# IREDELL COUNTY HEALTH DEPARTMENT

Statesville Office (704) 878-5305 Mooresville Office (704) 660-3625 PERMIT # 206970

## IMPROVEMENT PERMIT / AUTHORIZATION TO CONSTRUCT / OPERATION PERMIT / EXISTING SYSTEM

SITE ADDRESS: 348 Yacht Rd PHONE: (704) 201-4460 ALT. PHONE: (704) 892 7795 Ron Pfeffer

INITIAL SITE SKETCH

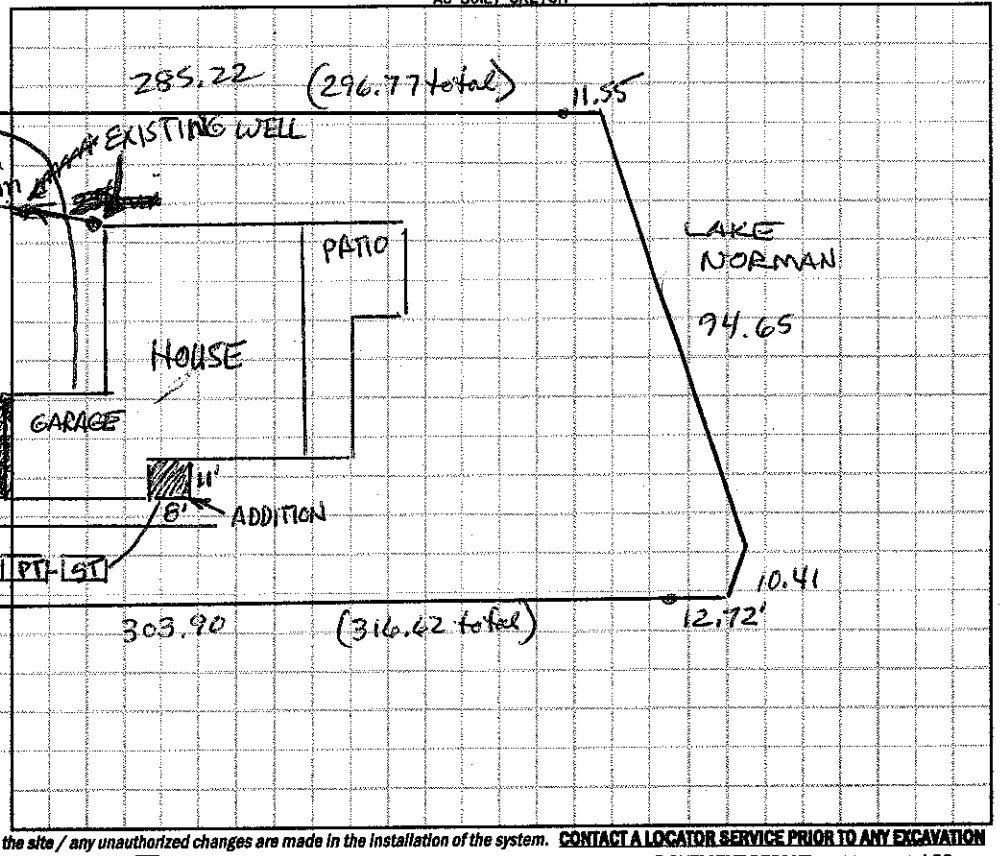
Comments / Conditions: AUTHORIZATION FOR ADDITION OF 1-CAR GARAGE SPACE (11x22) and PANTRY (8x11) ONLY. NO ADDITION OF BEDROOMS ABOVE EXISTING 3BR on 360 gal/day or change of use from single family dwelling. Dimensions Proposed by applicant hot field verified. Existing 12x60' bed installed in 2002 was discovered in 2008 when repair was done. 12x60' bed may be removed during addition construction

Location of the proposed garage and pantry addition does not appear to impact the existing on-site septic system or well. **NOTE:
